2.5 Geology, Seismology, and Geotechnical Engineering

In Section 2.5, “Geology, Seismology and Geotechnical Engineering,” of the site safety evaluation report (SSAR), the applicant, System Energy Resources, Inc. (SERI), provided a detailed description of the geological, seismological, and geotechnical engineering properties of the early site permit (ESP) site. In this safety evaluation report (SER), Section 2.5.1, “Regional Geology,” describes basic geological and seismological data, especially the data published since 1986 for the area within a 200-mile radius of the ESP site, and presents updated seismic sources. Section 2.5.2, “Vibratory Ground Motion,” evaluates the vibratory ground motion for the ESP site and analyzes the safe-shutdown earthquake (SSE) ground motion. Section 2.5.3, “Surface Faulting,” describes the potential for surface faulting at or near the surface of the ESP site. Section 2.5.4, “Stability of Subsurface Materials and Foundations,” presents the results of site geotechnical investigations and discusses the stability of subsurface materials and foundations. Section 2.5.5, “Stability of Slopes,” defers the analyses for slope stability at the site and dam perf

Figure 2.5.2-2 (SSAR 2.5-58)

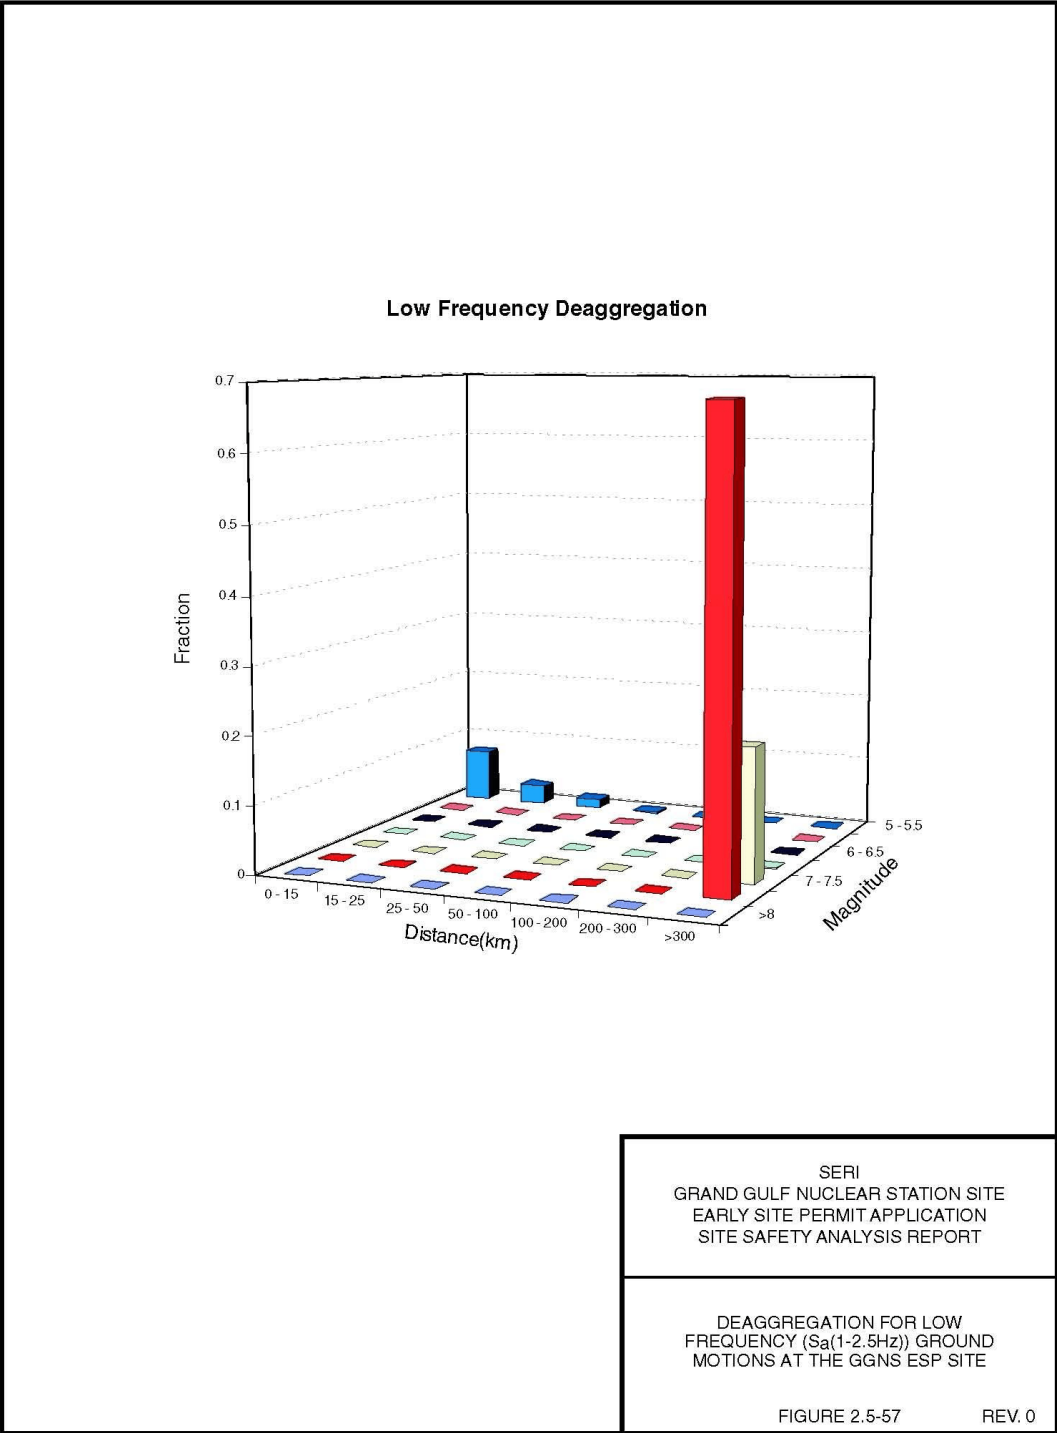
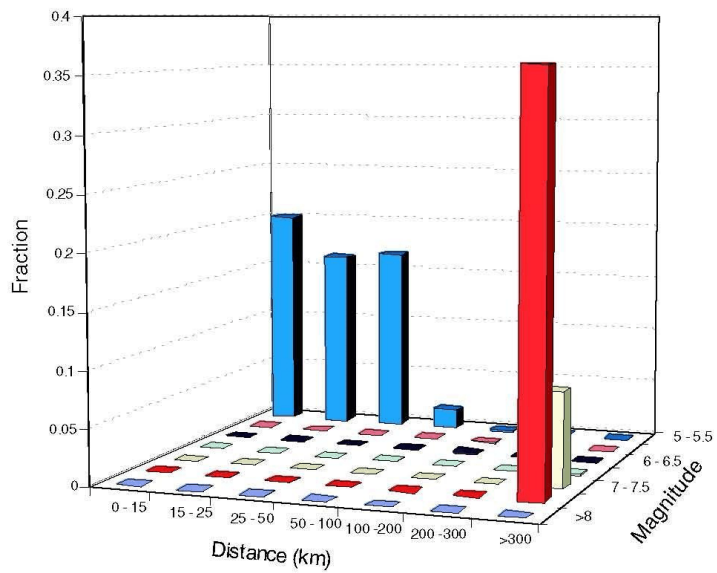
In RAI 2.5.2-8, the staff asked the applicant to explain why the mean hazard curves for the frequencies 0.5, 1, 2.5, 5, 10, and 25 Hz are shown above or approximately coinciding with the 0.85 fractile curves for higher spectral accelerations (SSAR Figures 2.5-48 through Figure 2.5-54). In its responses, the applicant stated that the results of a PSHA in which the epistemic uncertainty is modeled produce a probability distribution on the estimate of the annual frequency of exceedance of ground motions. The applicant further stated that experience indicates that this distribution is not symmetric (i.e., not Gaussian) and is typically skewed and approximately lognormal in shape. As a consequence, the mean of this distribution is skewed (higher) with respect to the median and the degree of skewness is a function of epistemic uncertainty. As the epistemic uncertainty increases, the tendency is for the mean to correspond to higher fractile estimates of the frequency of exceedance.

In RAI 2.5.2-9, the staff asked the applicant to explain why the SRSZ, with a magnitude as large as 6.0–7.0 and a distance at 81–206 miles, makes no contribution to the deaggregation results. In its response, the applicant stated the following:

The purpose of the magnitude-distance deaggregation is to provide a measure of the relative contribution of events (of different magnitude-distance pairs) to the total hazard. The deaggregation graphs in the SSAR show the relative contribution of earthquakes to the 10^{-5} median. The fact that events associated with the Saline River source (and all sources in this distance range) do not contribute to the 10^{-5} median hazard for the Grand Gulf site is primarily due to the fact that the overall rate of earthquake occurrences ($M_w > 5$) at these distances is extremely low. Further, the rate of occurrence of earthquakes of magnitude 6.0–7.0 is thus much lower. The result is that the estimated ground motion hazard at the Grand Gulf site is extremely low and, in a relative sense, makes little or no contribution to the 10^{-5} median hazard.

Figure 2.5.2-3 (SSAR Figure 2.5-59)

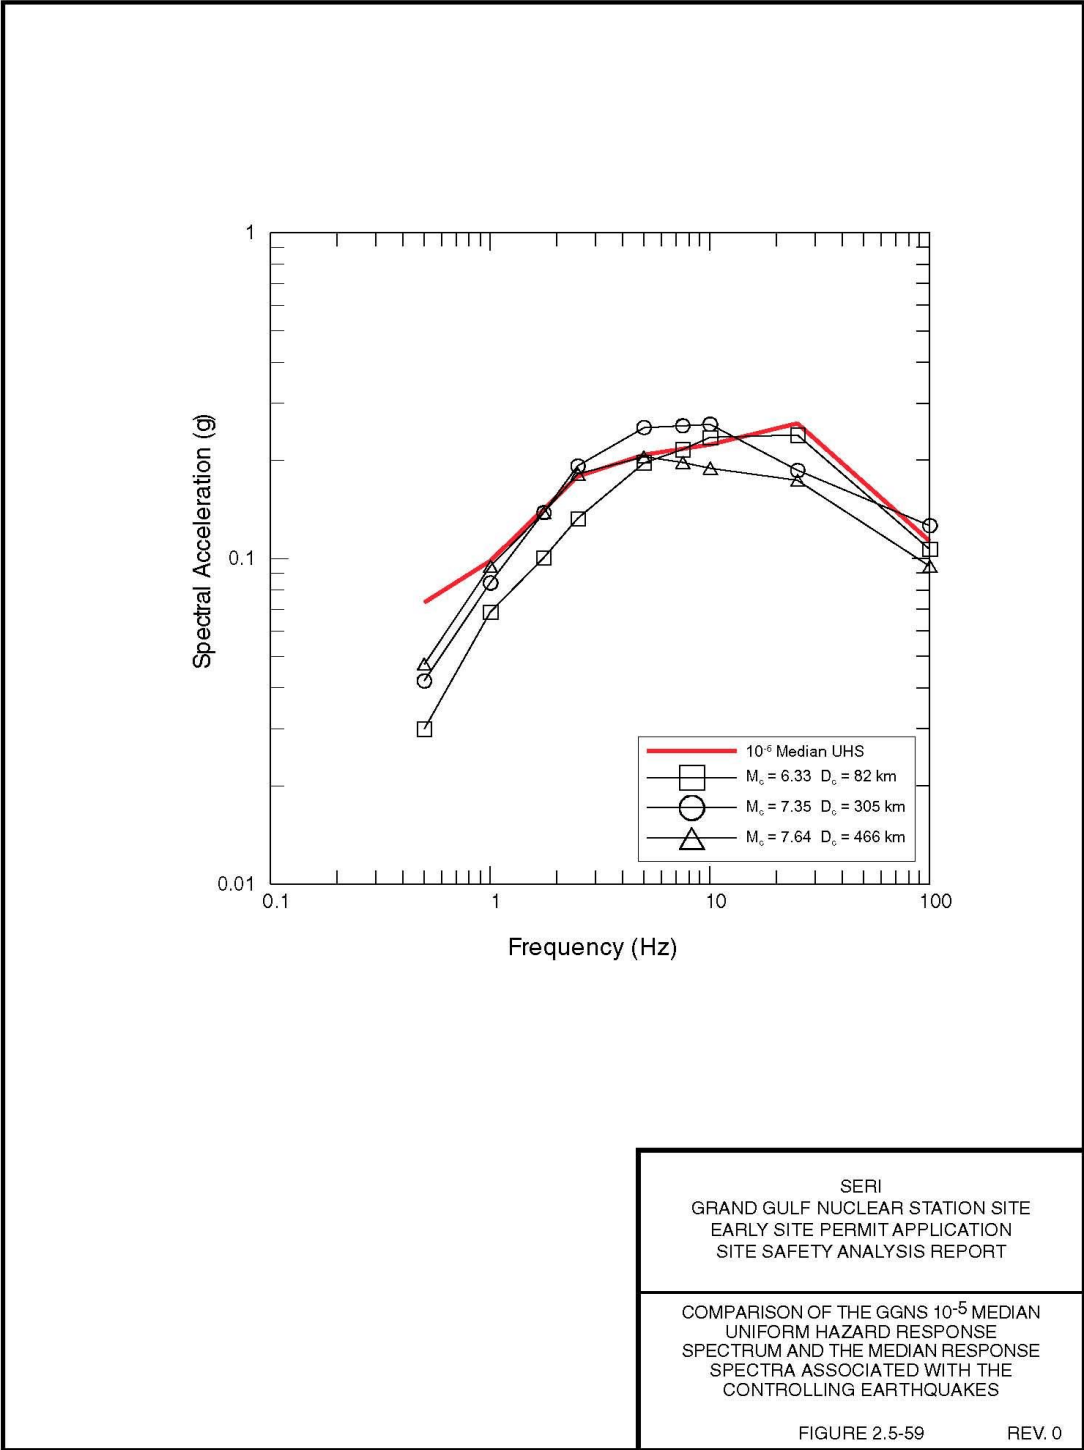
In RAI 2.5. 2-10, the staff asked the applicant to provide an explanation as to why the magnitude-distance bin, including the controlling earthquake, does not contribute to the high-frequency deaggregation. In its response, the applicant stated that the controlling earthquake for a given frequency range is the mean magnitude and mean distance of the deaggregation distribution. If deaggregation is multimodal or bimodal as in the Grand Gulf case, the resulting mean may not correspond to the magnitude values that are actually defined in the distribution.

The applicant's response to RAI 2.5.2-10 adequately explained why the high-frequency deaggregation graph shows no contribution from the magnitude-distance bin that contains the controlling earthquake.
